To: Auburn Planning Board  
 From: Megan Norwood, City Planner  
 Re: Site Plan/Special Exception: Construction of a 5,100 Square Foot Building Addition and Parking Expansion for a Total of 139 Parking Spaces at the 76 Merrow Road Western Maine Transportation Services Building, (PID: 178-017)  
 Date: April 13, 2021

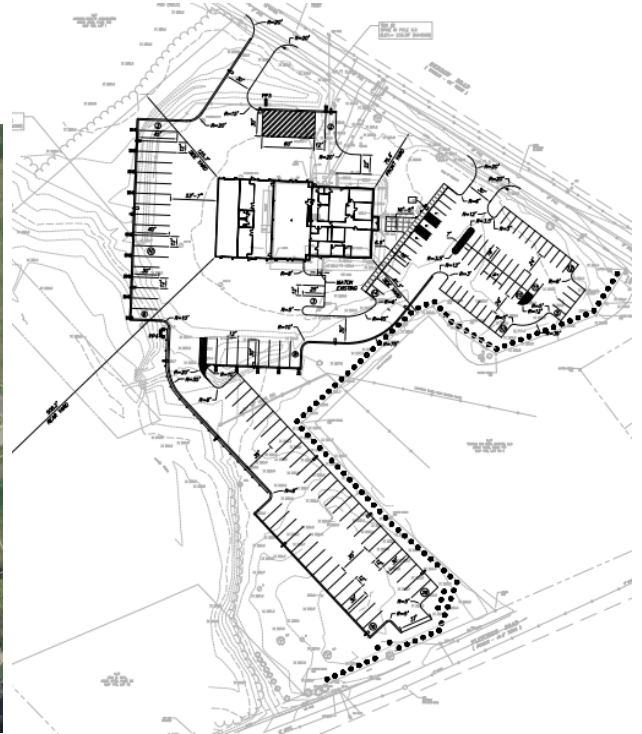
(10) Any parking or loading space serving a business or industrial use which abuts the side or rear lot line of a lot in a residential district or use shall be screened from said lot by a tight evergreen shrub hedge or similar landscaping, a fence, a solid wall or a combination of two or more of the foregoing. The screen landscaping, wall or fence shall be at least six feet high and may be extended no closer than 15 feet from the street line. *Where this is a corner lot, there is a front setback on Merrow Road and a side setback on Fletcher road, all other setbacks are considered "sides." The side lot lines abutting the neighboring properties on Fletcher Road are in the Rural Residential District. The Applicant has increased the amount of landscaping provided in these areas and most of the rear lot line is already heavily buffered. The area where some additional plantings may be helpful is circled below.*
